ADDENDUM NO. 1  
ELEMENTARY CLASSROOM ADDITION &  
HS GYM REMODEL  
BARTON-LEXA SCHOOL DISTRICT  
BARTON, ARKANSAS  
Project No. 17092

May 15, 2018

The proposed Contract Documents, dated May 1, 2018, have been modified as follows:

**AD1.1**

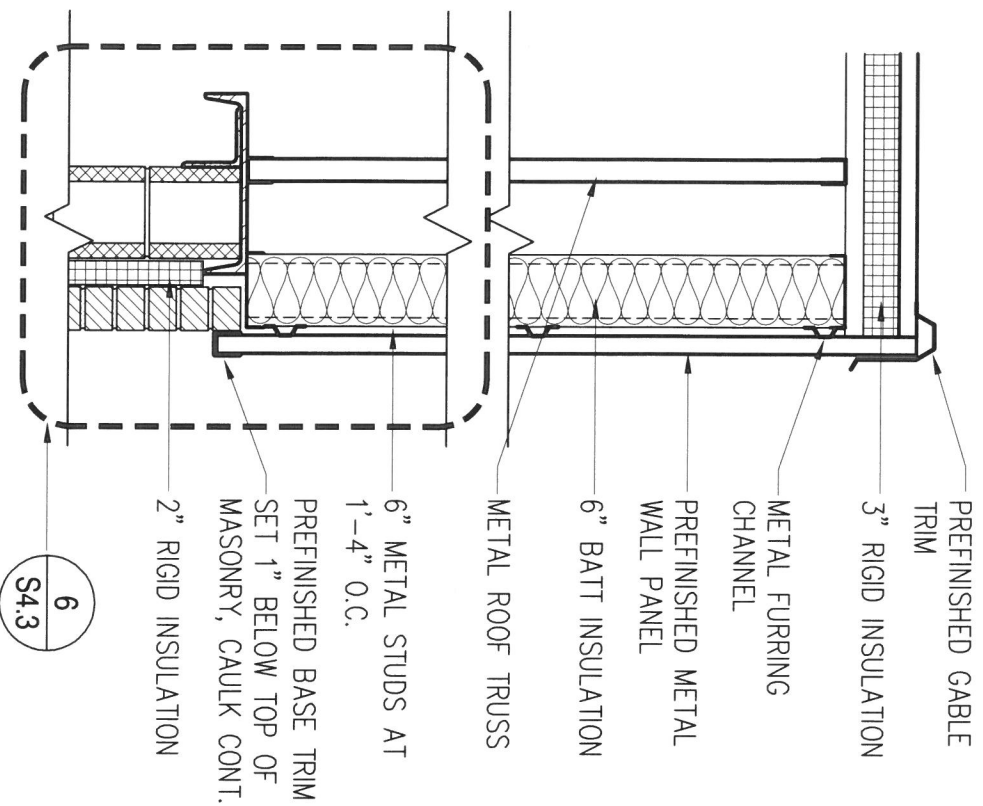
- Item #9: Sheet E2.1 Floor Plan – Power & Systems: Revise underground service to MDP as shown on attached 8.5x11 sheet AD1.1.
- Item #10: Sheet E2.1 Floor Plan – Elementary – Power: Keyed Note #2 should correctly refer to 45A/2P breaker, in lieu of, 50A/2P noted. Coordinate exact breaker size with final submitted wall packaged units.

# 1 WALL SECTION

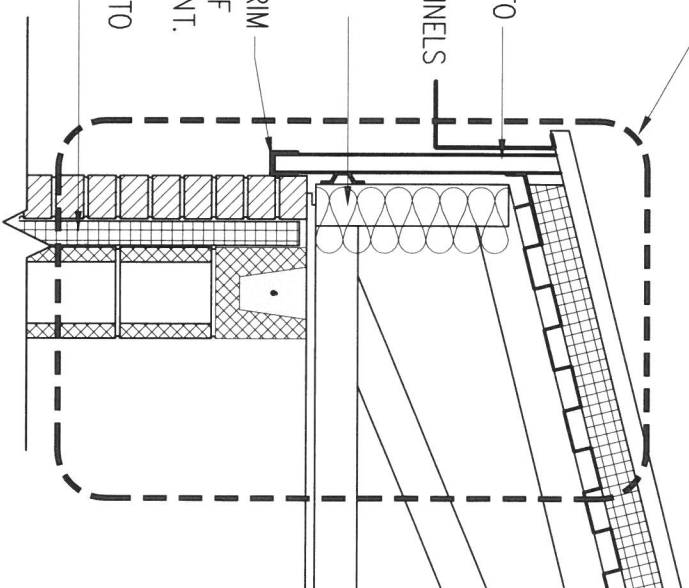
- b. Note 8 – Change to read “Remove partial endwall”.
- Item #6: Sheet A4.1 – Section 2 - Classroom Building Section: Use 1/AD1.0 (attached) in lieu of referenced X/A4.3.

6" METAL STUDS AT 1'-4" O.C.  
 PREFINISHED BASE TRIM SET 1" BELOW TOP OF MASONRY, CAULK CONT.  
 2" RIGID INSULATION
